May 27, 2022

**RE: Response to National Park Service questions on Sunnyside Cogeneration Associates Four Factor Analysis – Dry Sorbent Injection Considerations**

**Sunnyside Cogeneration Associates**  
**Four Factor Analysis - Dry Scrubber Cost Analysis**

**Figure 2. General Plant Layout<sup>16</sup>**

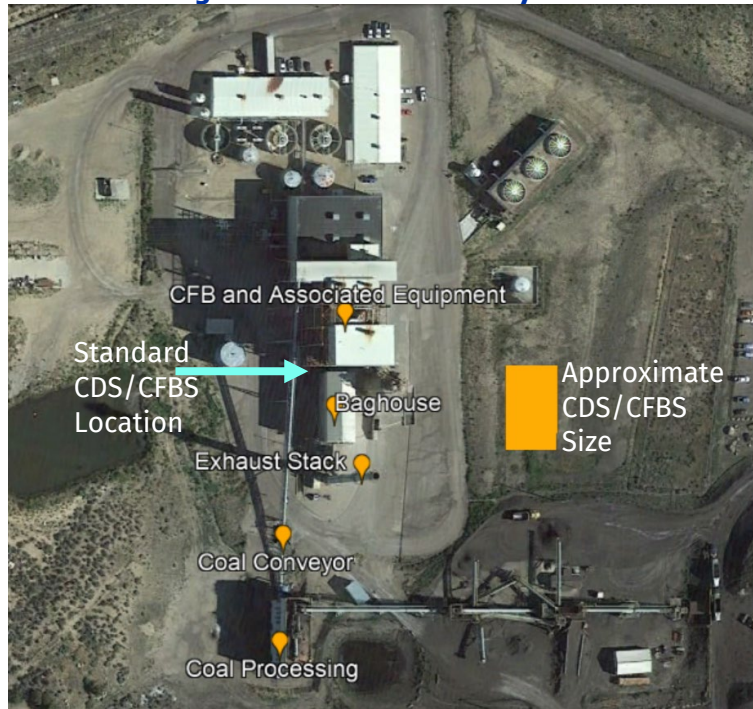
Beyond the detailed technical challenges associated with integration of the existing baghouse into a new CDS/CFBS system there is also a plant design challenge. As demonstrated in the photos below, there is insufficient space to install a CDS/CFBS between the boiler and existing baghouse. For all these reasons the CDS/CFBS is no longer an add-on technology that can be simply fastened to existing equipment as implied by the NPS's statement. Significant re-engineering time and cost would be required to maintain the CFB boiler's air flow balance and ensure it functions as designed.

Based on the site configuration, the limited space around the CFB boiler would need to be considered to support the addition of a CDS/CFBS system.
